RE: *PDC17-047 & PD18-015 – Planned Development Zoning and Planned Development Permit for Real Property Located at 1330, 1388 and 1410 S. Bascom Avenue
(Item 10.2 - September 10, 2019 City Council Agenda)*

Re: SOUTH BASCOM GATEWAY STATION
SCH 2019069109 — *Mitigated Negative Declaration*

San Jose Vasona Quiet Zone Diagnostic Review Meeting Notes (DRAFT)

Bascom Station North (Pedestrian)

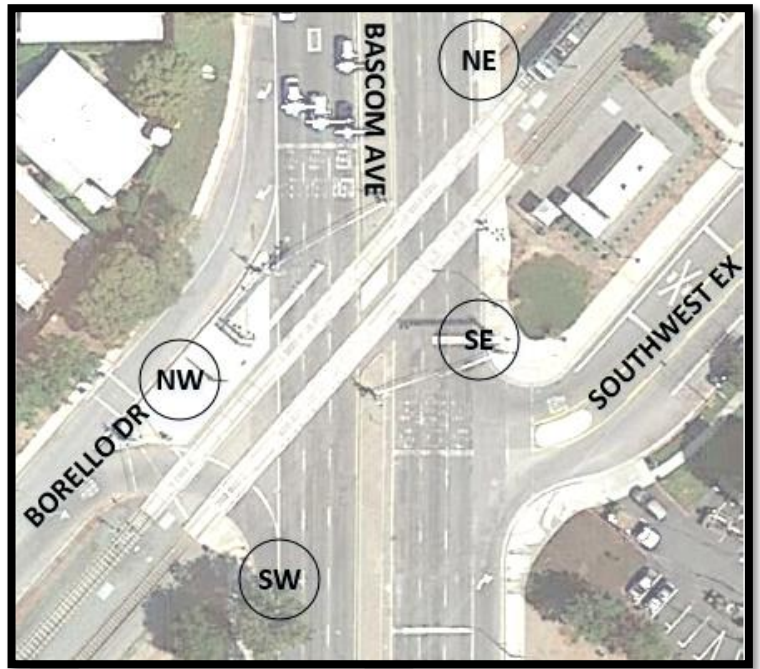
1. Crash History 2007 - 2019: none
2. Land Uses: multifamily residential; development proposed on the triangular parcel to the northwest of Bascom LRT Station will provide pedestrian access to both station entrances; the development includes 600 residential units, 300,000 square feet of commercial space, and a 200,000 square feet office building

3. CPUC submitted a comment letter to City of San Jose Planning on 8/5 in which it recommended that the proposed development on the northwest quadrant:

- Install Commission Standard 9 pedestrian automatic gates with EXIT swing gates and channelization at both pedestrian station crossings.
 - Relocate the detectable warning strips outside of the swing gates at the two pedestrian station crossings.

4. Consider standard sign set up at all station crossings; perhaps move "Look Both Ways" and "No Train Horn" signs to swing gates
5. Crossbuck signs on posts need to be rotated to face pedestrians coming from outside the crossing- rotate or add another crossbuck sign facing the nearest approach

6. Replace signs damaged with graffiti (immediate action item)
7. Swing gates need maintenance (immediate action item)
8. Striping across tracks to delineate edge of pedestrian path needs to be refreshed

9. Relocate detectable warning strips to outside of crossing
10. Future development on the west side of the rail corridor will need a Commission Standard #8 flasher on west side of tracks

11. Blue ENS should be relocated to the post with the crossbucks as is typical at other ped crossings
12. There is a "Look Both Ways" sign in between the tracks; consider removing, or relocate to swing gate
